DesignFlow

17 March 2011

**RE: ADDENDUM TO YARRABILIBA PRECINCT 1 STORMWATER MANAGEMENT PLAN**

Figure 1: Location of Northern Catchment (which was not considered in the Yarrabilba Precinct 1 Stormwater Management Plan)

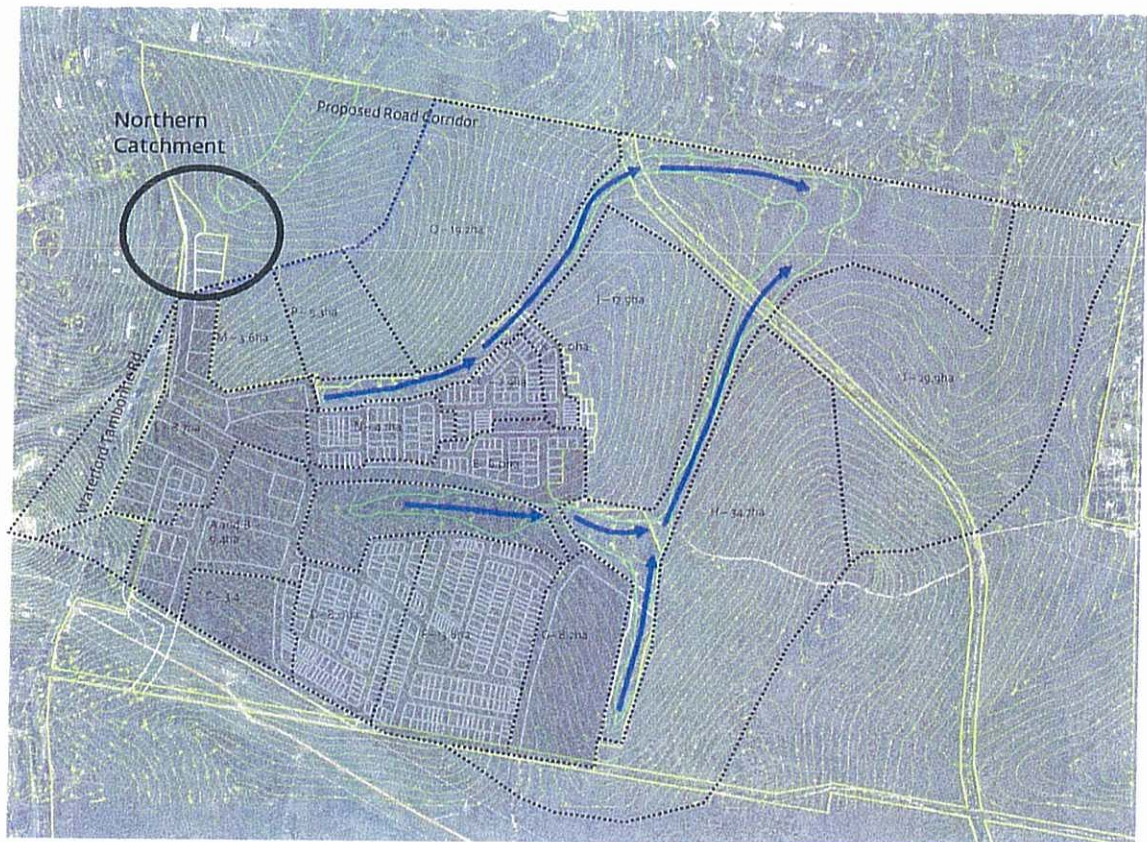
This email provides additional information for the stormwater management strategy for Yarrabilba Precinct 1. As highlighted in Figure 1, the far northern component of Precinct 1 was excluded from the stormwater planning because it is situated outside the catchment we have focused on in the Stormwater Management Plan (SMP).

Figure 2: Stormwater management strategy for Northern Catchment (including pre and post development catchments)

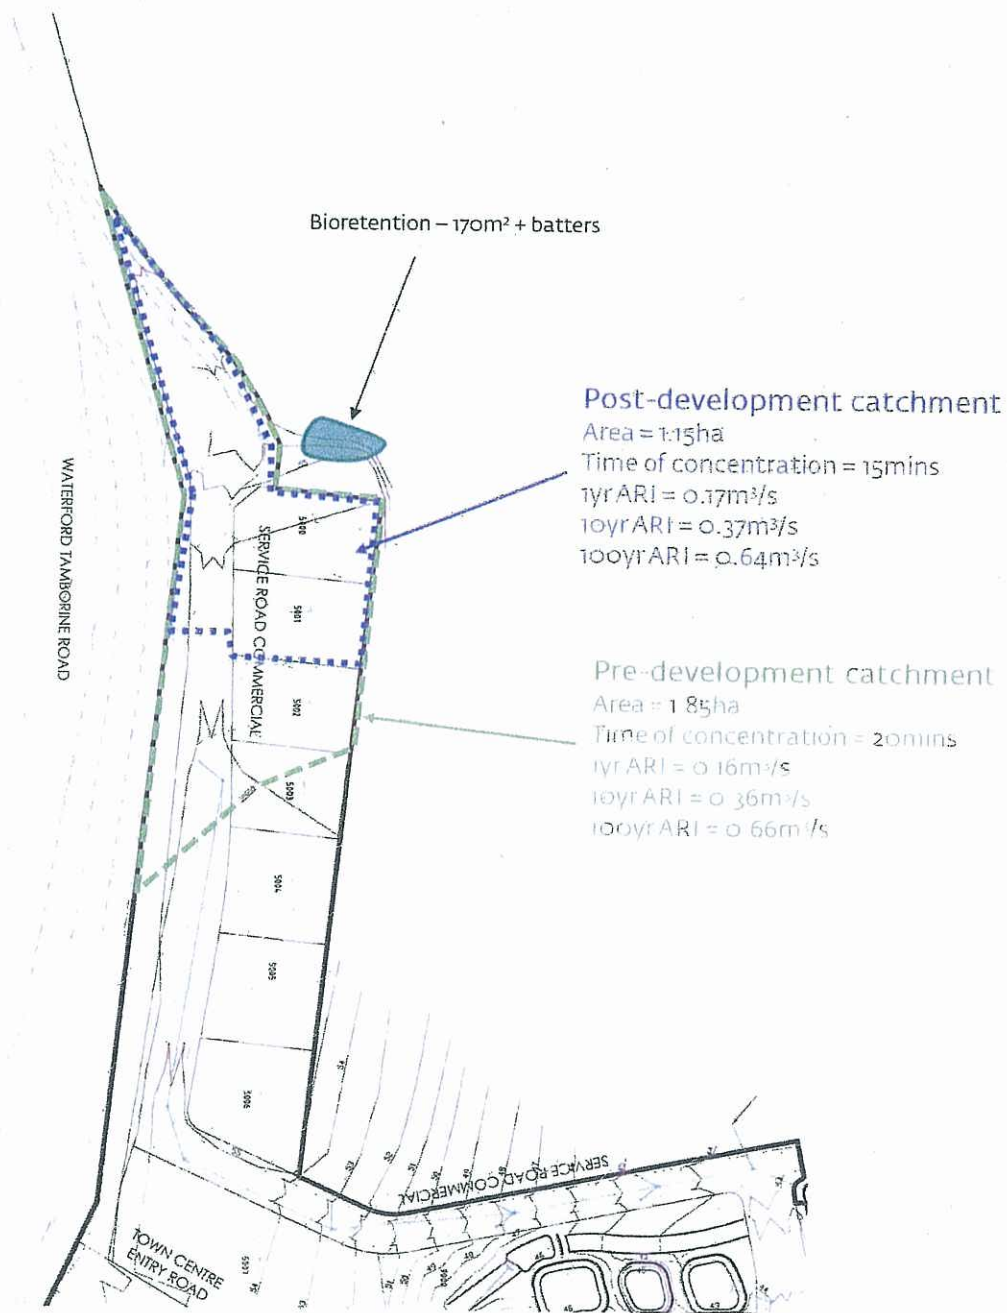
Figure 2 illustrates the pre development and post development catchments for this portion of the Precinct 1 development. The proposed earthworks will result in a reduction in the catchment areas as summarized below:

- Pre development = 1.85ha
- Post development = 1.15ha

In order to meet the stormwater quality management objectives (80% reduction in TSS, 60% reduction in TP and 45% reduction in TN) a 170m<sup>2</sup> bioretention system is proposed to receive runoff from the 1.15ha post development catchment. The location of the bioretention system is illustrated in Figure 2. This bioretention system will be temporary and will be ultimately replaced with another stormwater strategy for the whole catchment in this zone once the urban design is resolved. The bioretention system will be placed to avoid significant vegetation.

The 0.7ha catchment that drains south into the Precinct 1 will be accommodated and treated with the Precinct 1 Stormwater Strategy. This will require a minor adjustment to the proposed Bioretention B4 within Precinct 1 from 1450m<sup>2</sup> to 1500m<sup>2</sup>.
